**Subject: Proposed Technical Changes  
Renewable Energy Approval (No. 2318-8Q6PXQ)  
Crosby Solar Project**

Northland Power Inc. is proposing to develop and operate a 10-megawatt (MW) solar photovoltaic facility located at 249 Little Rideau Lakes Road in the Township of Rideau Lakes, within the United Counties of Leeds and Grenville. This project is herein referred to as the “Crosby Solar Project” or the “Project”.

The Ministry of the Environment (MOE) issued a Renewable Energy Approval (REA) for the Project (No. 2318-8Q6PXQ) on January 20, 2012. Since issuance of the approval, Northland Power has conducted detailed engineering and is proposing revisions to the site plan for the facility, specifically the location of the access road and the placement of Project fencing within the original leased boundary for the Project.

Figure 4.1  
 Northland Power Inc.  
**Crosby Solar Energy Project**  
 Water Body and  
 Project Boundaries

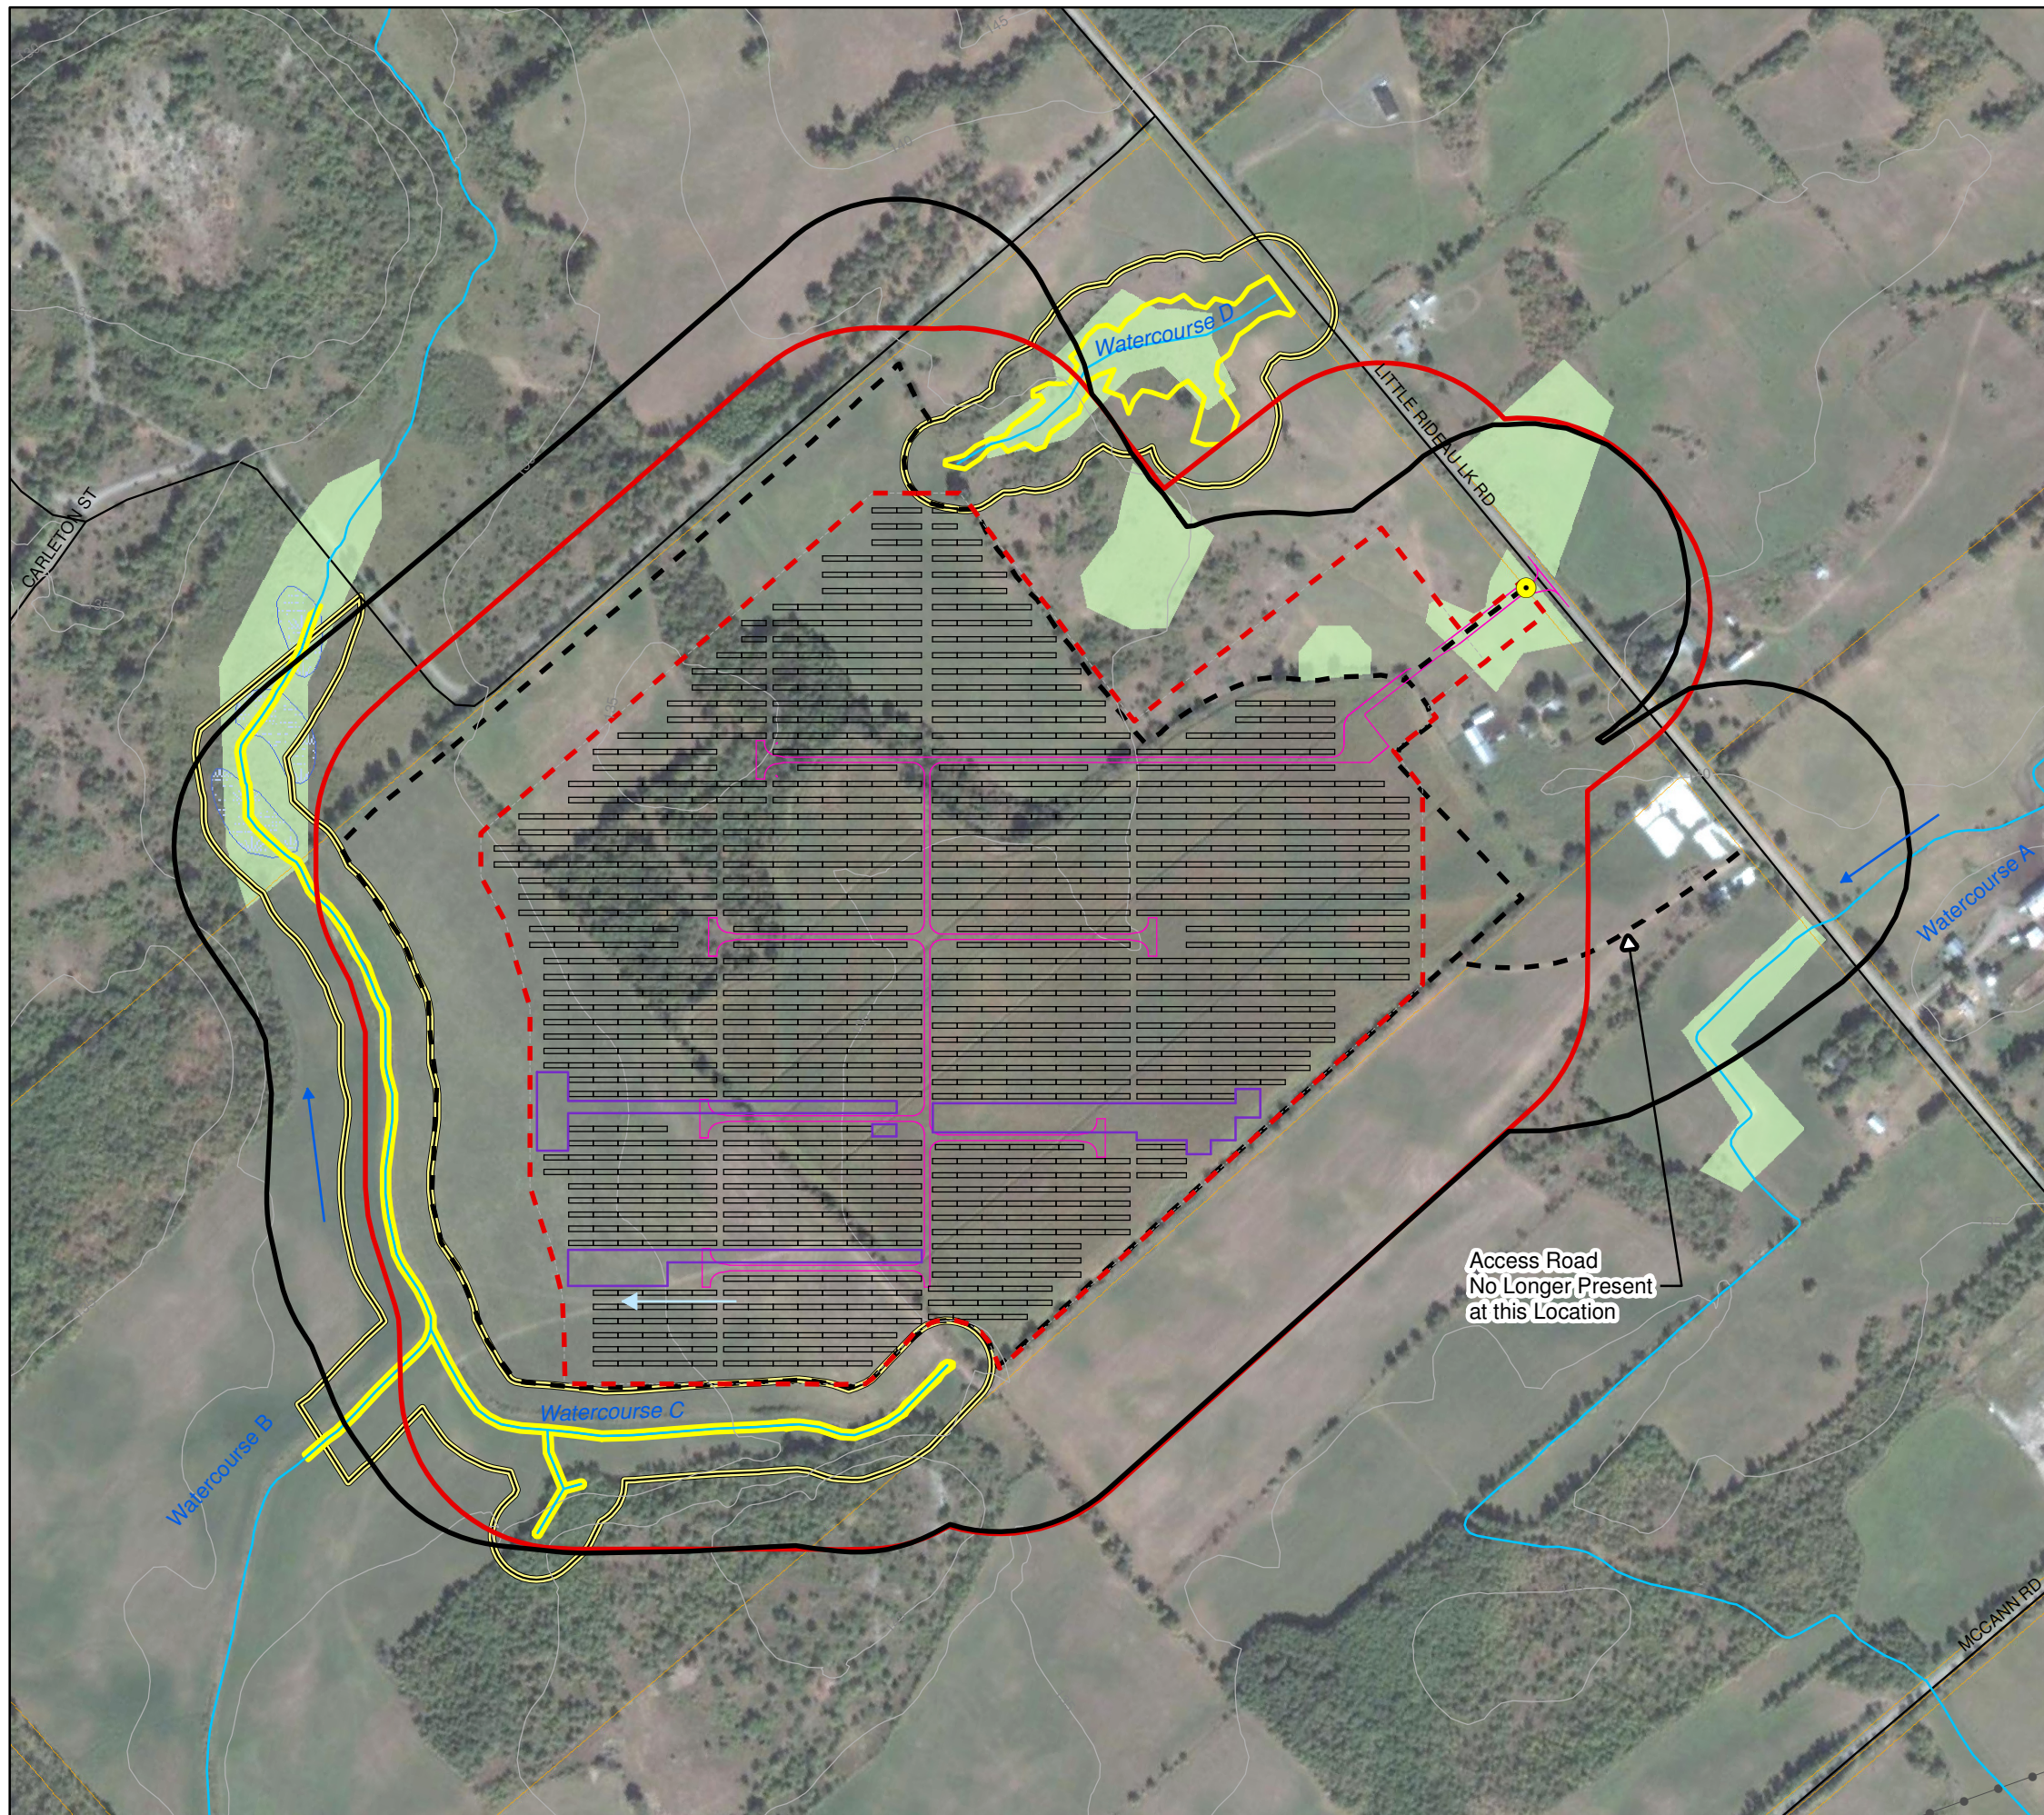
Page	Section	Original Text	Amended Text
10	4.1.2	As shown in Figure 4.1, the Project footprint boundary is between 30 and 120 m from the average annual high water mark. Therefore, an EIS will be required to assess the potential for adverse effects and mitigation measures required to prevent/minimize these adverse effects.	As shown in Figure 4.1, the Project footprint boundary is 20 m from the average annual high water mark. Therefore, an EIS will be required to assess the potential for adverse effects and mitigation measures required to prevent/minimize these adverse effects.
12	4.1.4	The proposed development area will occur within 30 to 120 m of the average annual high water mark of Watercourse D (Figure 4.1), therefore, an EIS will be required to assess potential adverse effects and mitigation and monitoring measures.	The proposed development area will occur within 20 m of the average annual high water mark of Watercourse D (Figure 4.1), therefore, an EIS will be required to assess potential adverse effects and mitigation and monitoring measures.

7	Figure 4.1	Original Water Bodies and Project Boundaries	See attached revised Figure 4.1 (Attachment C).

Figure 1.1  
 Northland Power Inc.  
**Crosby Solar Energy Project**  
**Project Components**  
**and Significant**  
**Natural Heritage Features**

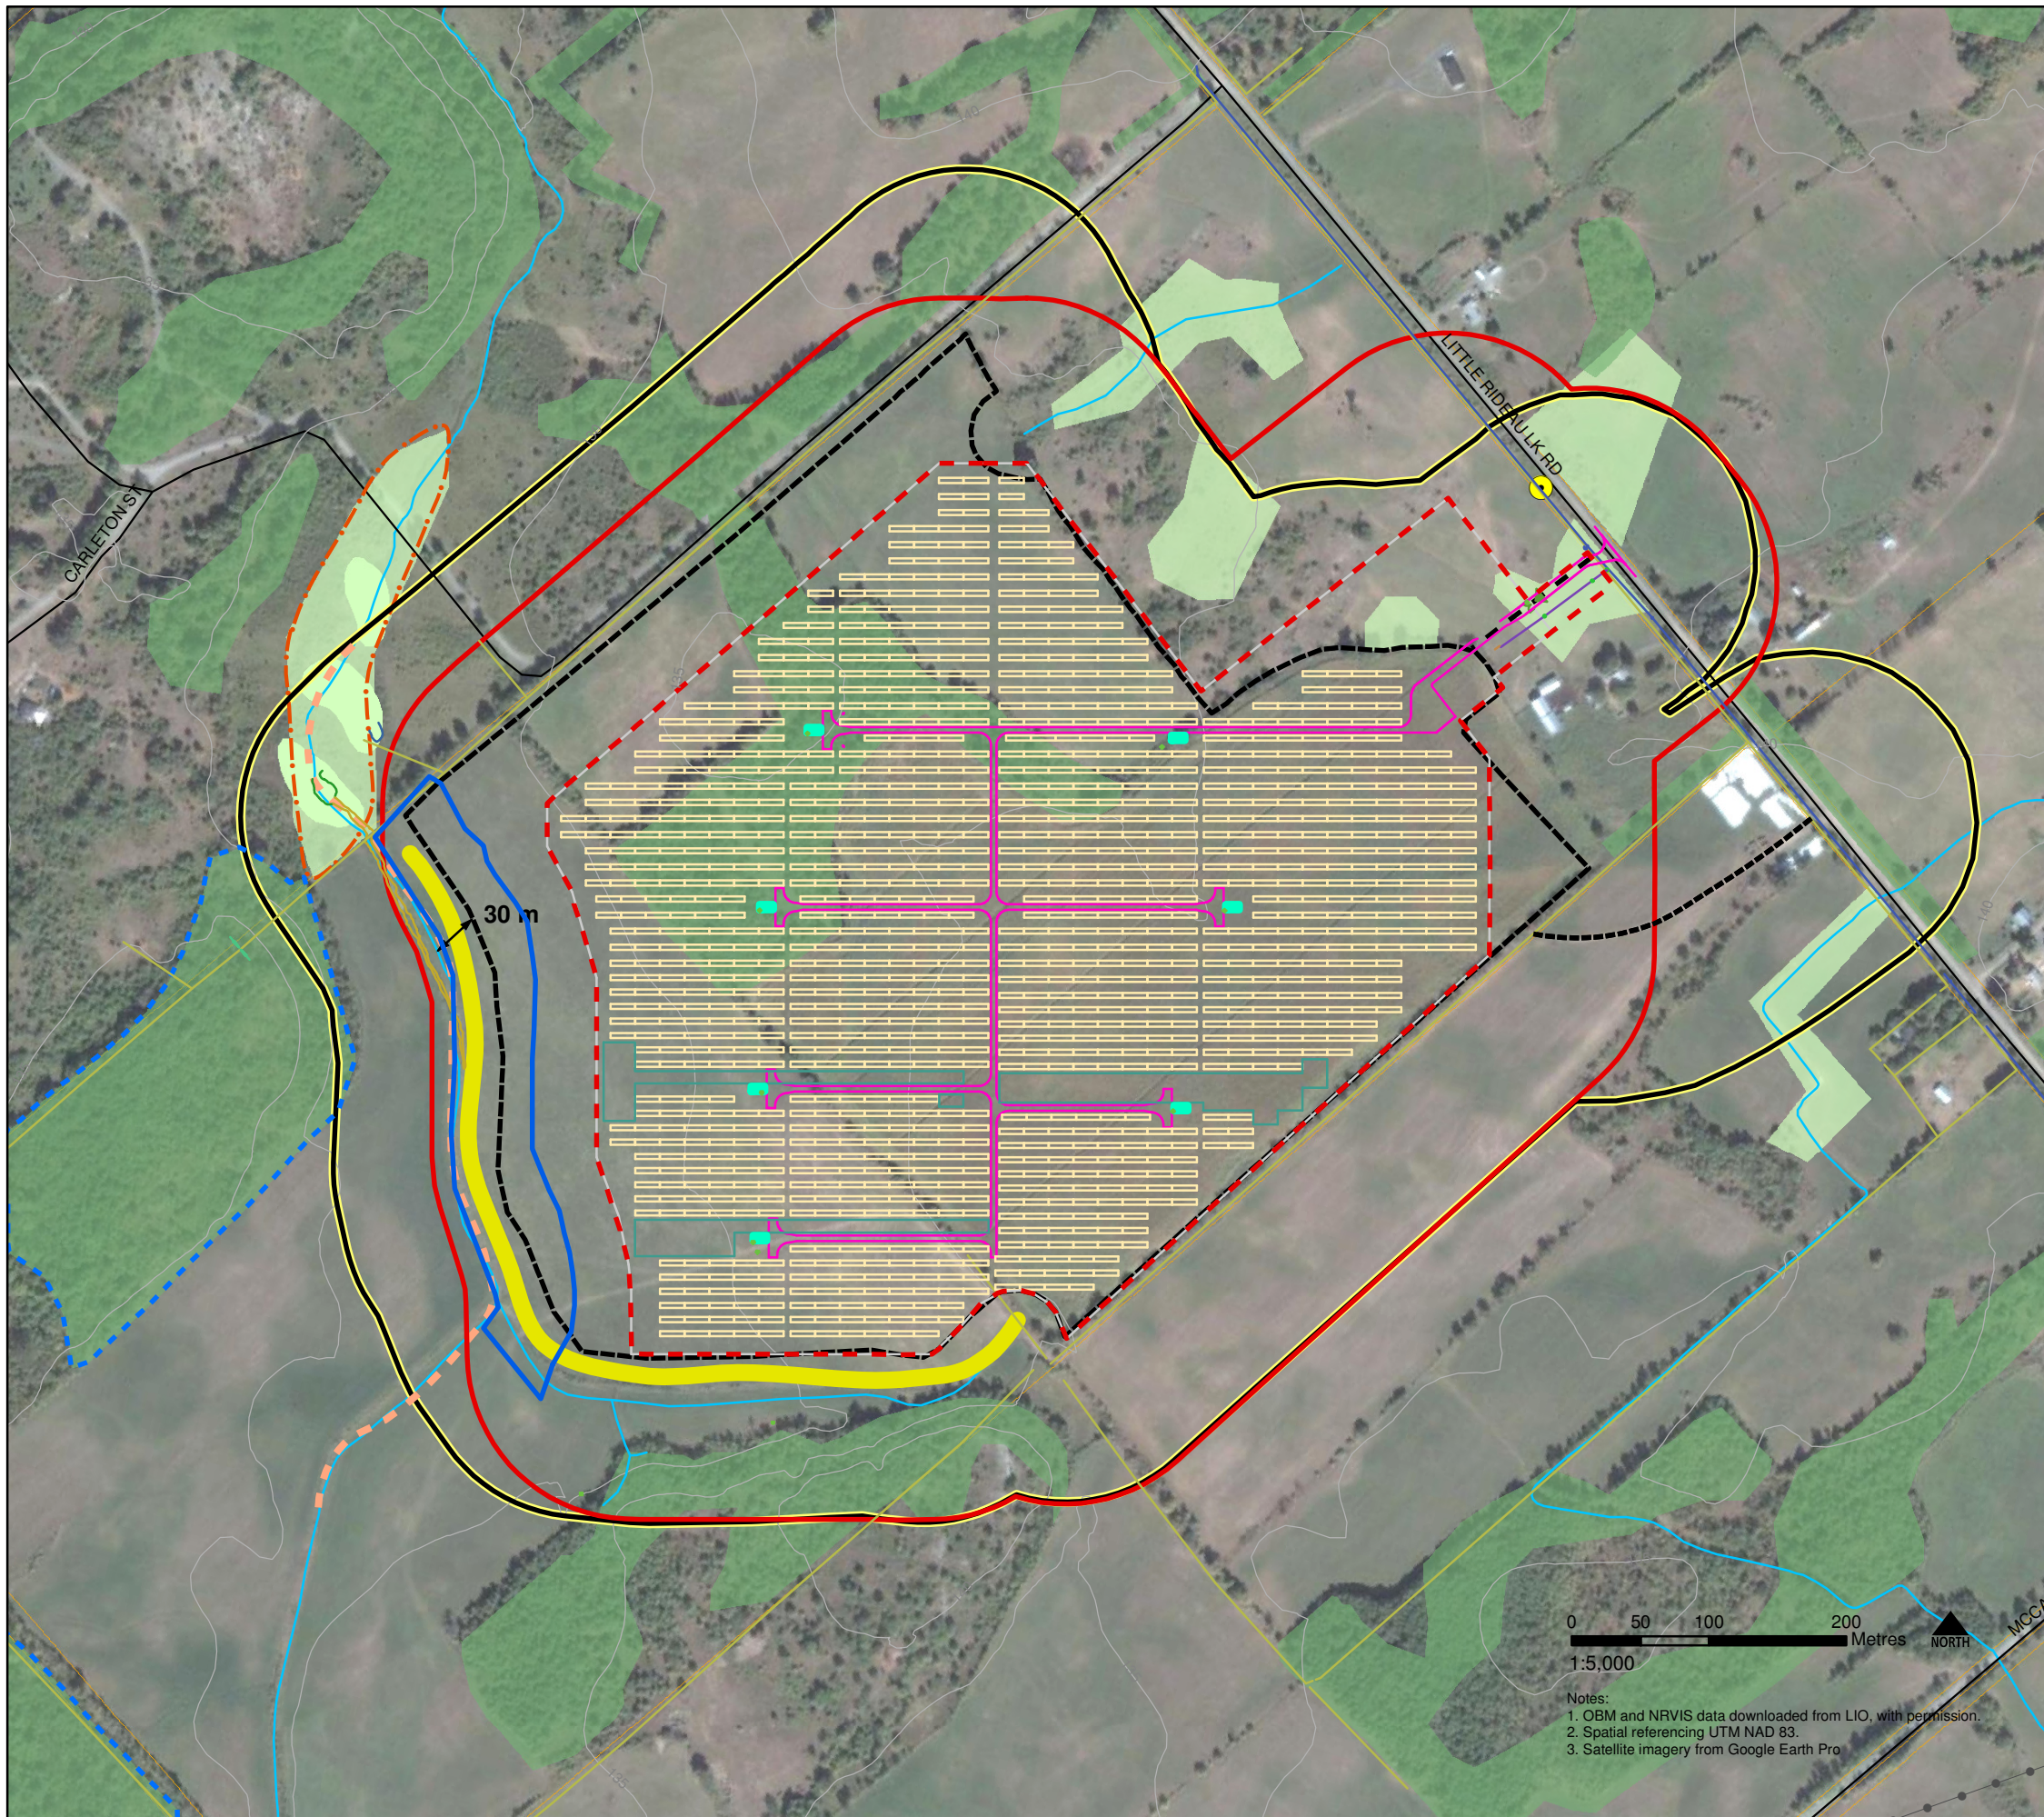
A revised site plan is provided in Attachment A. Specifically, there have been two modifications to the proposed layout:

- Locations of fencing have been revised to be located at the edge of the land leased for the Project. This has resulted in reductions in the extent of the Project location along the western, northwestern, and southeastern boundaries of the Project, and increases in the extent of the Project location in the northeastern boundary of the Project.
- The location of the access road has been revised such that it no longer enters off the southeastern corner of the site, and has moved north and is paired with the power line

that connects the Project to the distribution line. This reduces the amount of access road required for the Project.

The currently proposed location of the access road will require construction within a non-provincially significant wetland, as assessed within the Natural Heritage Evaluation of Significance report for the Crosby Solar Project (Hatch, 2011). As this feature is not provincially significant, this change does not require assessment within the Environmental Impact Study for the Project, and no mitigation measures are required.

However, Northland will use best management practices during construction within the wetland community in order to minimize potential impacts. This will include delineation of work areas for the access road, use of sediment and erosion controls, such as silt fencing, during construction of the road, and installation of a 50-cm diameter culvert within the access road to maintain hydraulic connectivity between portions of the wetland.
